PLANNING
 Client
 RFU
 Project
TWICKENHAM STADIUM EAST STAND EXTENSION
 Drawing title
EXTERNAL WORKS - ZONE 1 LANDSCAPING / TURNSTILE SETTING OUT PLANS

Doc ref	Project number	Drawing number	Revision
100-KSS-DR	15735	1000	P02

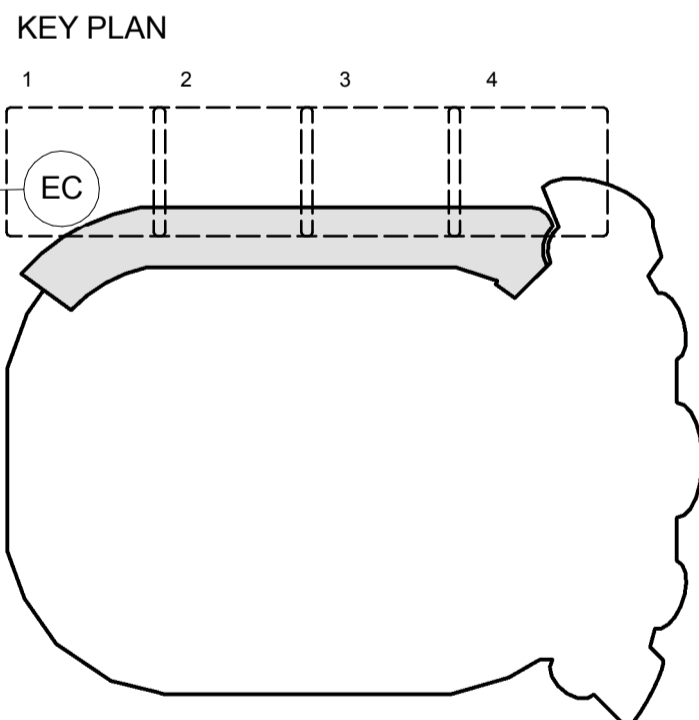
PLANNING AMENDMENTS	
A	GENERAL AMENDMENTS TO THE SOUTH END. INCREASED SHINGLES CLADDING AREA AND CURTAIN WALL REDUCED ACCORDINGLY.
A1	REDUCED MASSING AND REVISED INTERFACE WITH THE SOUTH STAND.
A2	PPC LOUVRES LOCATED TO THE BOWL SIDE HAVE BEEN OMITTED.
B	CURTAIN WALL SETTING OUT REVISED GENERALLY. SILICONE JOINTS TO TRANSOMS AND MULLION REPLACED WITH CAPPED SYSTEM. LEVEL 04 PPC LOUVRES SETTING OUT & HEIGHT REVISED. MONORAIL FOR ABSEILING REMOVED.
C	GENERAL AMENDMENTS TO THE CENTRAL ELEVATION CANOPY AT LEVEL 5A REVISED GENERALLY AND STANDING SEAM REPLACED WITH SINGLE PLY MEMBRANE. SUPPORT COLUMNS TO ROOF CANOPY REVISED. SQUARE FASCIA TO ROOF EDGE.
D	LEVEL 5A GLAZED SCREEN EXTENDED IN HEIGHT AND PPC LOUVRES INCLUDED AT LOW LEVEL.
D1	INCREASED SHINGLES CLADDING AREA AND CURTAIN WALL AREA REDUCED ACCORDINGLY. FOUR VERTICAL FINES REMOVED.
D2	PORCELAIN PANELS WITH SLOTTED HOLES FOR VENTILATION REPLACED WITH PPC LOUVRES. EXPRESSED HORIZONTAL PATTERN TO PORCELAIN PANELS OMITTED.

D3	GENERAL AMENDMENTS TO THE NORTH END PORCELAIN CLADDING REPLACED WITH PPC ALUMINIUM CLADDING.
E	GREEN WALL TO THE NORTH END EXTENDED AND PPC LOUVRES REMOVED.
E1	INCREASED SHINGLES CLADDING AREA AND CURTAIN WALL REDUCED ACCORDINGLY.
E2	FENCELINE, GATE AND PERIMETER COLUMNS SETTING OUT REVISED.
E3	CANOPY TO TURNSTILES REVISED.
F1	PORCELAIN PATTERN CHANGED FROM HORIZONTAL TO VERTICAL.
G	PORCELAIN PANELS TO THE SOFFIT OF THE ARCH REPLACED WITH PPC ALUMINIUM PANELS. PORCELAIN PANELS SETTING OUT REVISED.
H	ROOF TO LEVEL 5A (NORTH END) EXTENDED.
K	GLAZED SPANDREL PANELS REPLACED WITH METAL SPANDREL PANEL. PORCELAIN PANELS REPLACED WITH PPC ALUMINIUM CLADDING.
L1	PPC LOUVRES INCLUDED FOR MECHANICAL VENTILATION.
